ADDENDUM NO. 1

Project: **2022 ROAD MAINTENANCE PROJECT**
Owner: **City of Dripping Springs Texas**
Engineer: **B. Ryan Bell, P.E. – Project Engineer**
Date: **October 3, 2022**

Bidders are hereby notified of the following revisions and/or clarifications to the construction plans, contract documents and specifications. This Addendum forms a part of the Contract and clarifies, corrects, or modifies original Bid Documents.

PAVING DETAILS

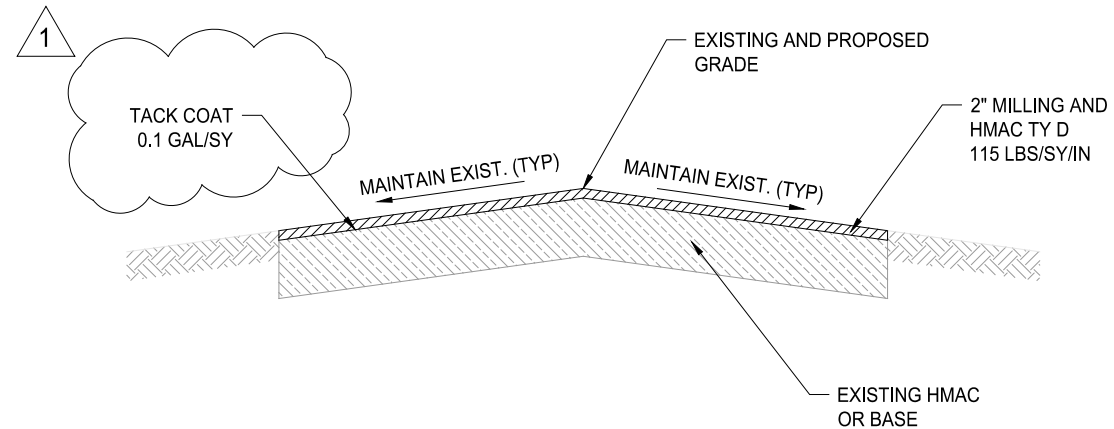
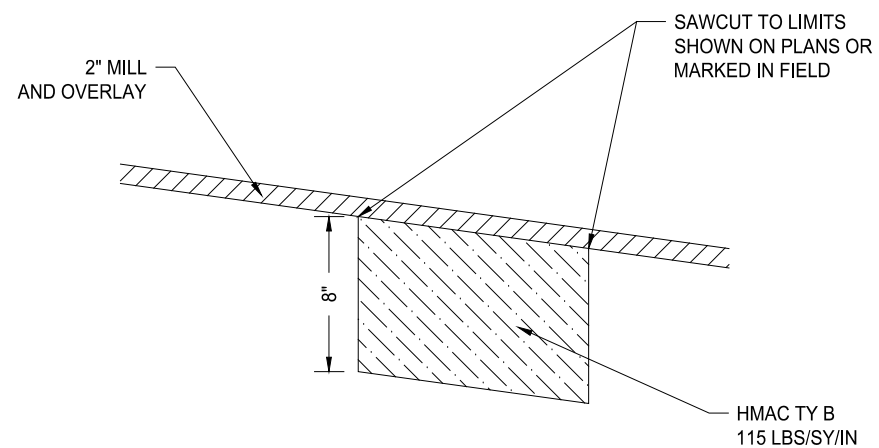
Sheet 10 of 14 – PAVING DETAILS

2. **QUESTION:** *The rate for the Tack Coat is shown on the plans as .20 GAL/SY which is very heavy (this is the rate for a Prime Coat on flex base). According to the HAYS County Specs the TACK COAT shall conform to COA 307S, "Tack Coat" which specifies the following: "The asphaltic material shall be applied on the clean surface by an approved type of self-propelled pressure distributor, so operated as to distribute the tack coat at a rate not to exceed 0.10 gallon per square yard (0.45 liters per square meter) of surface, evenly and smoothly with sufficient pressure to provide proper distribution". This pay item is bid by the SY so there will not be a price adjustment for rate adjustments (FYI), we would prefer to see it by the gallon in accordance with TxDOT Specifications so the City will only pay for what is used on the project. Also note, that Tack Coat will need to be applied to the entire area of the overlay which is 3,208 SY (x .10 rate = 321 gallons), Pay Item 4 on the bid form is showing 2,568 SY. Can this be reviewed and corrected?*

REPLACE – Sheet with the attached version.

RESPONSE: The tack coat rate has been changed to 0.1 GAL/SY in the plans. Quantities have been updated to be shown in units of gallons instead of square yards. The tack coat quantity has been updated to be applied to the entire area of the overlay.

SIGN MOUNTING DETAILS SMALL ROADSIDE SIGNS GENERAL NOTES & DETAILS

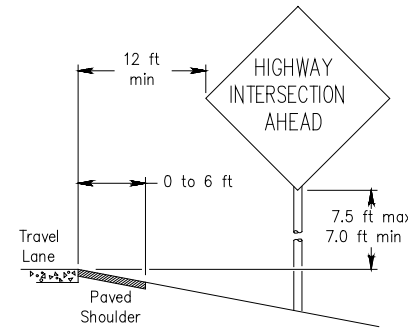
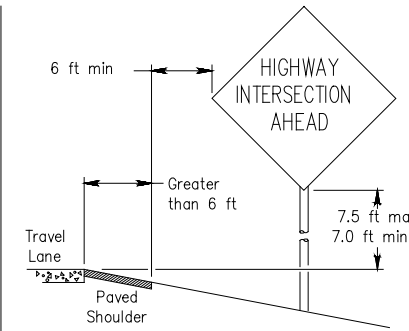
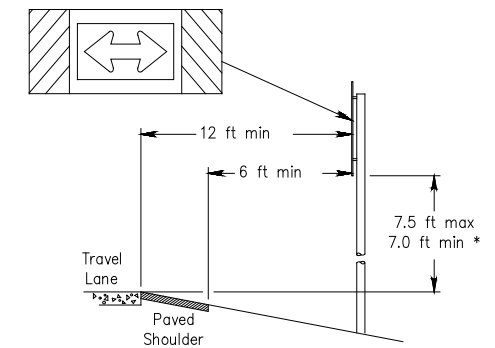
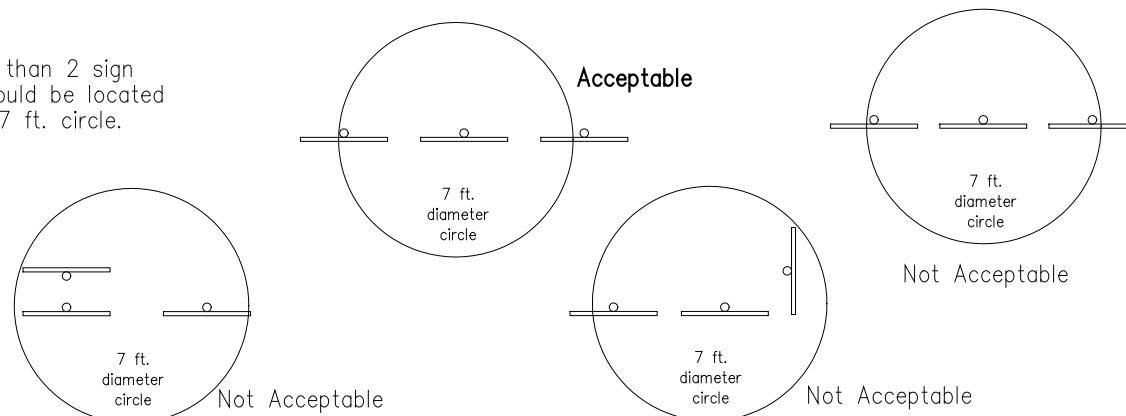
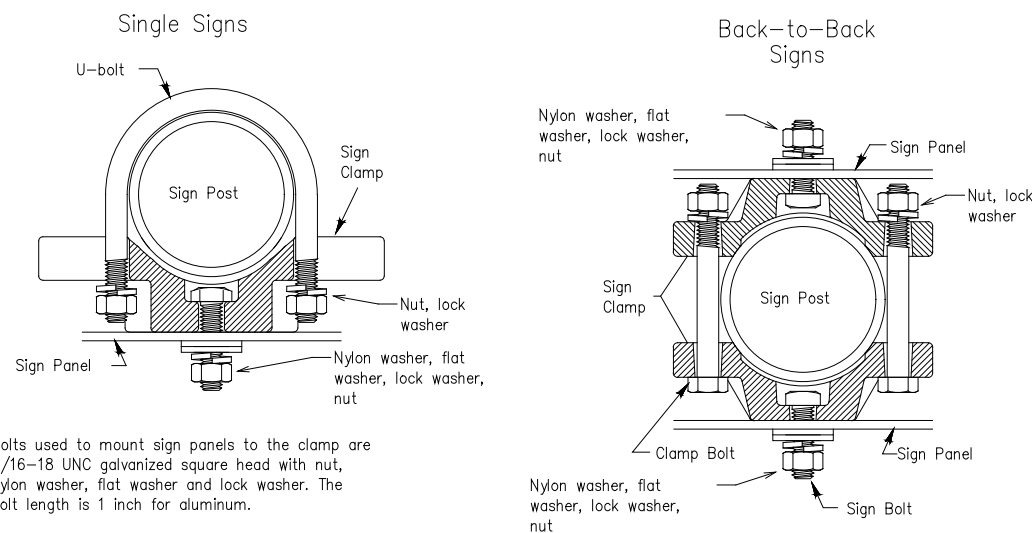
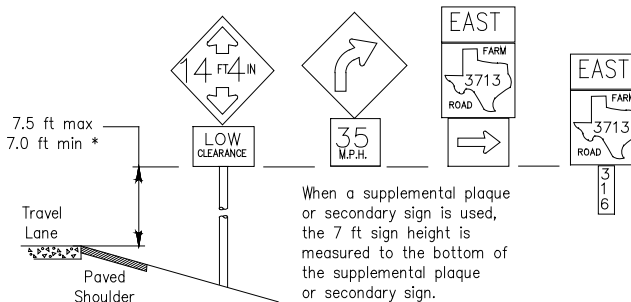
Sheet 11 of 14 – SIGN MOUNTING DETAILS SMALL ROADSIDE SIGNS GENERAL NOTES & DETAILS SMD(GEN)-08

6. **QUESTION:** *Do you have a detail for Bid Item #9 644-6001 IN SM RD SN SUP&AM TY10BWG(1)SA(P)? Are these for the R3-8 signs shown on 5 of 10 at the intersection of RR 12 & Mercer Street?*

ADD – New sheet

RESPONSE: Details have been added to describe bid item 644-6001 IN SM RD SN SUP&AM TY10BWG(1)SA(P). See sheets 11-14.

SIGN MOUNTING DETAILS
SMALL ROADSIDE SIGNS
TRIANGULAR SLIPBASE SYSTEM

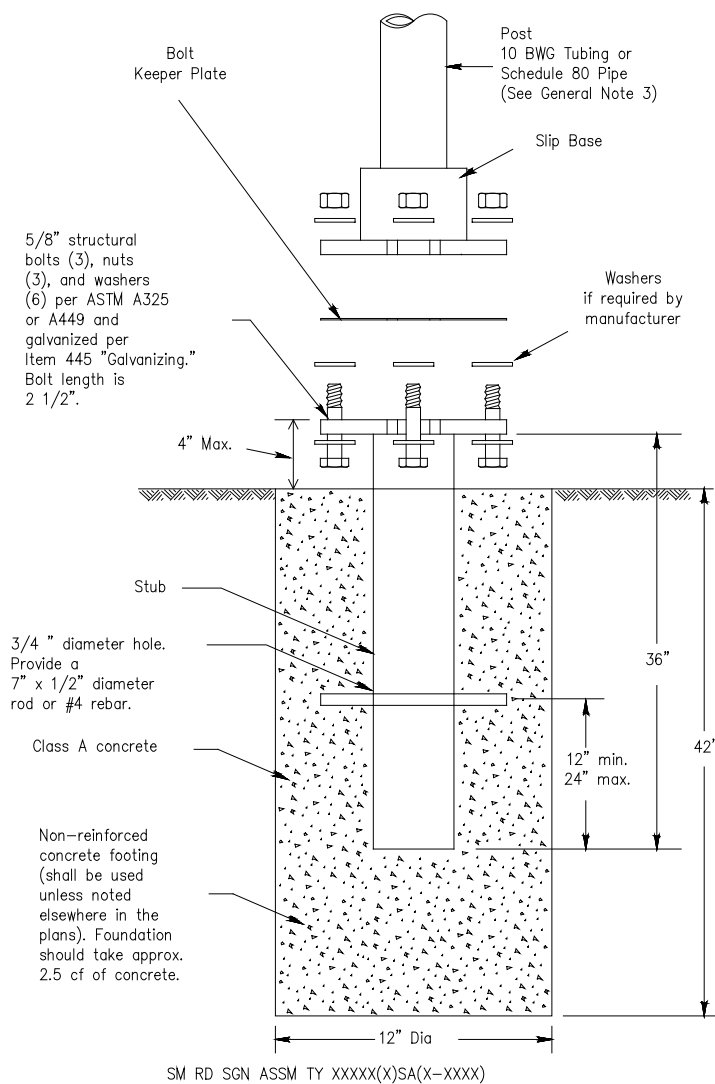
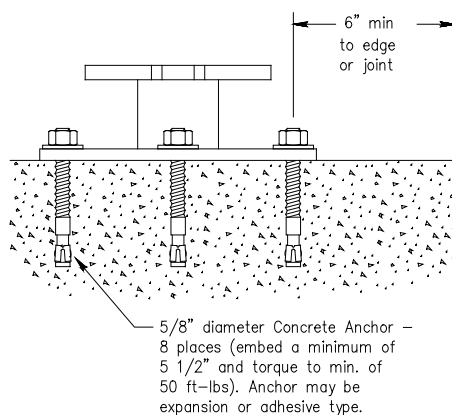
Sheet 12 of 14 – SIGN MOUNTING DETAILS SMALL ROADSIDE SIGNS TRIANGULAR SLIPBASE SYSTEM SMD(SLIP-1)-08

ADD – New sheet

SIGN MOUNTING DETAILS
SMALL ROADSIDE SIGNS
TRIANGULAR SLIPBASE SYSTEM
SMD(SLIP-2)-08

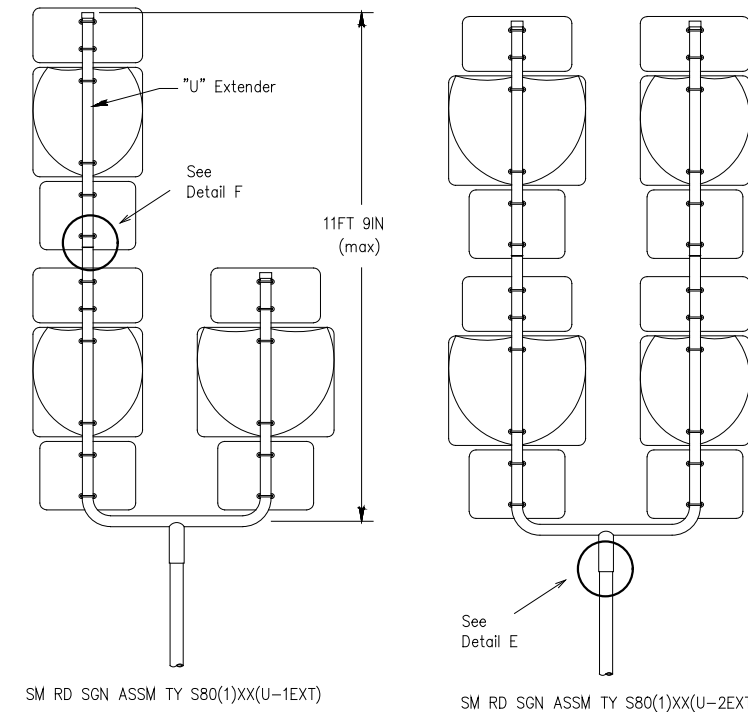
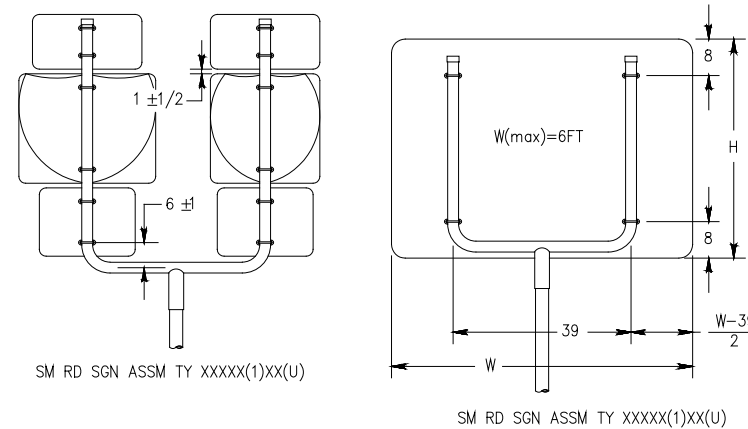
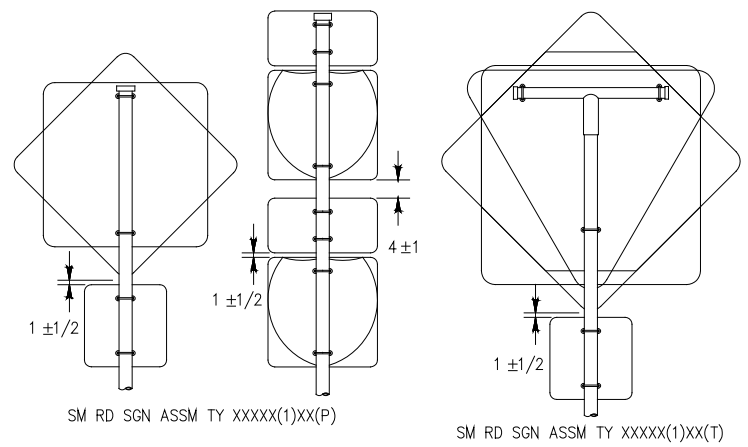
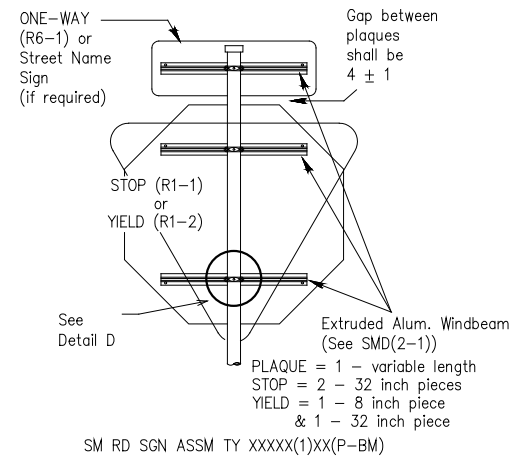
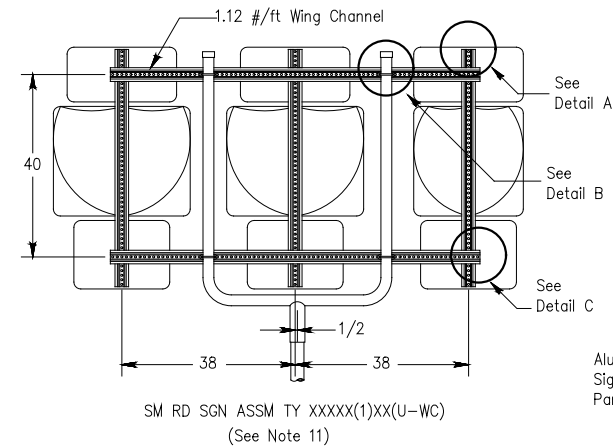
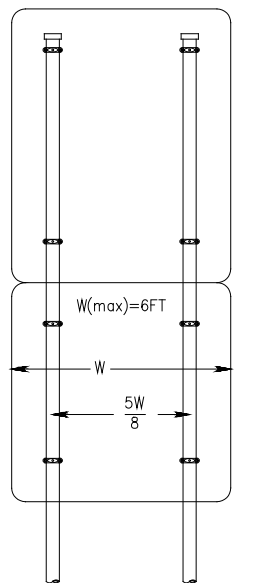
Sheet 13 of 14 – SIGN MOUNTING DETAILS SMALL ROADSIDE SIGNS TRIANGULAR SLIPBASE SYSTEM SMD(SLIP-2)-08

ADD – New sheet

SMD(SLIP-3)-08

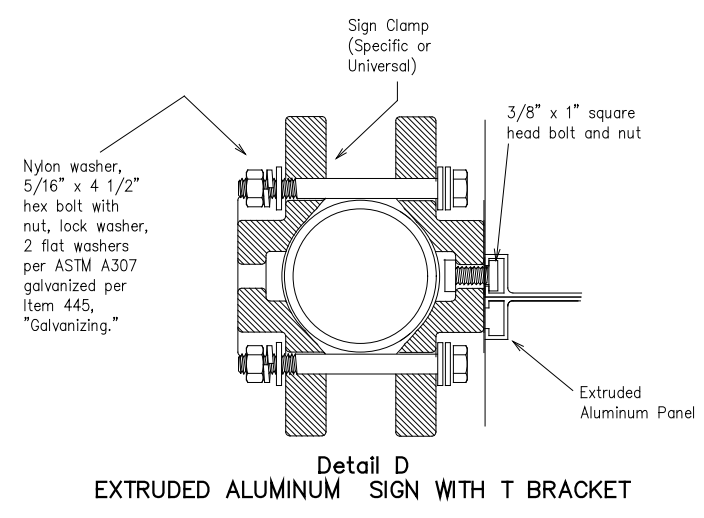
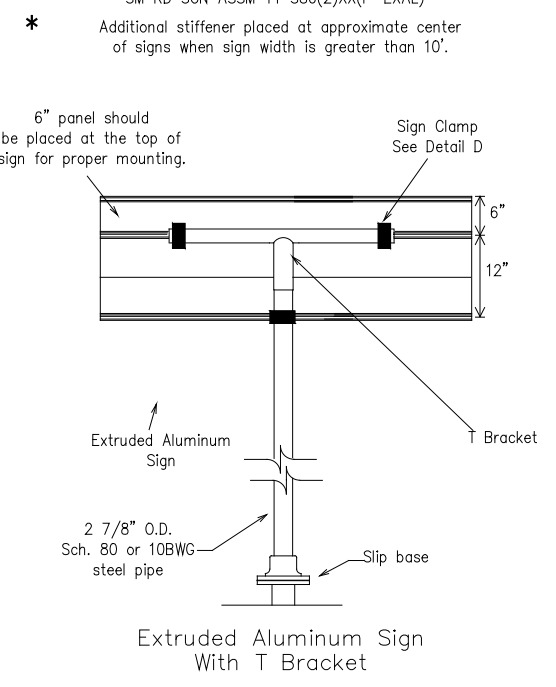
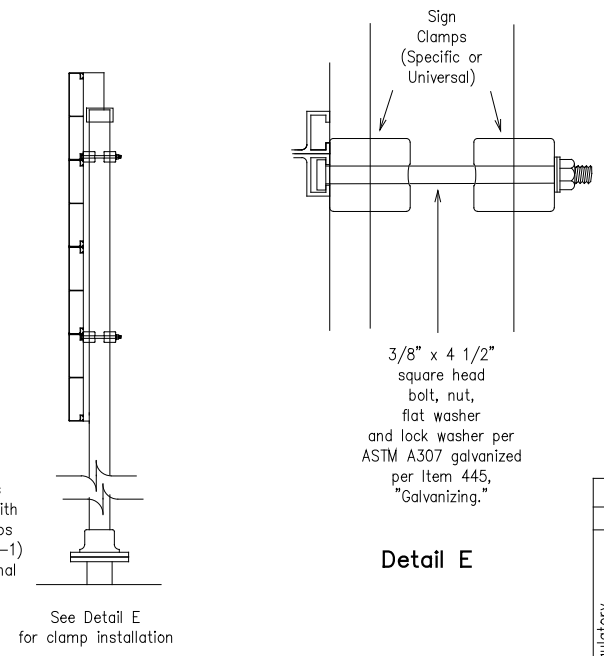
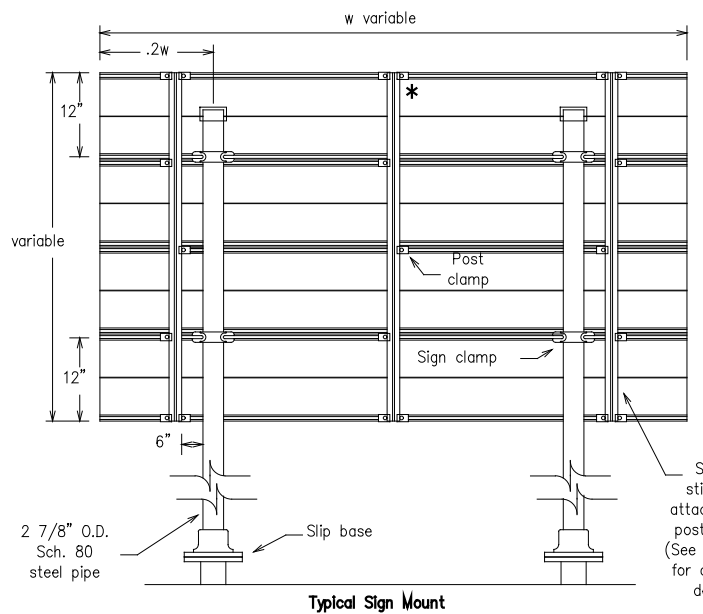
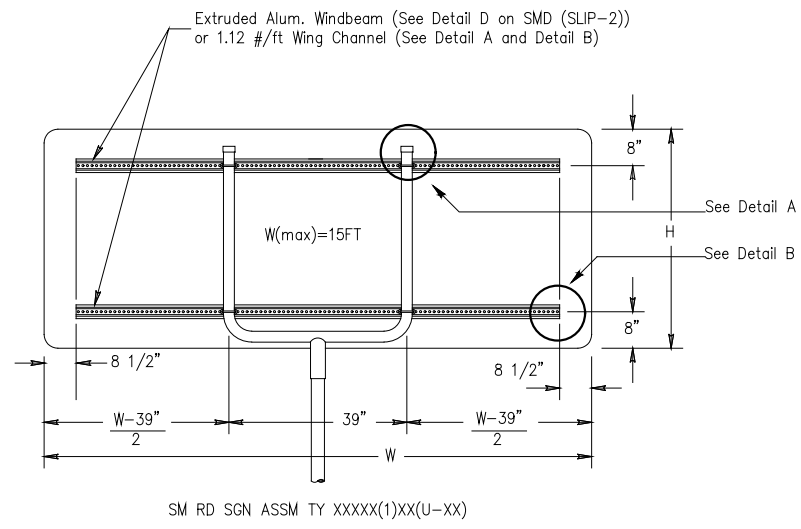
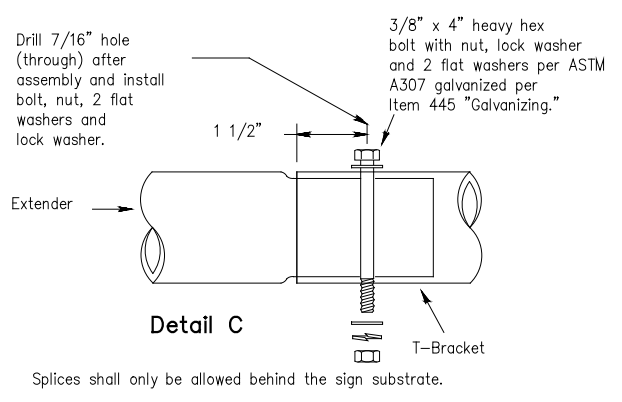
Sheet 14 of 14 – SIGN MOUNTING DETAILS SMALL ROADSIDE SIGNS TRIANGULAR SLIPBASE SYSTEM SMD(SLIP-3)-08

ADD – New sheet
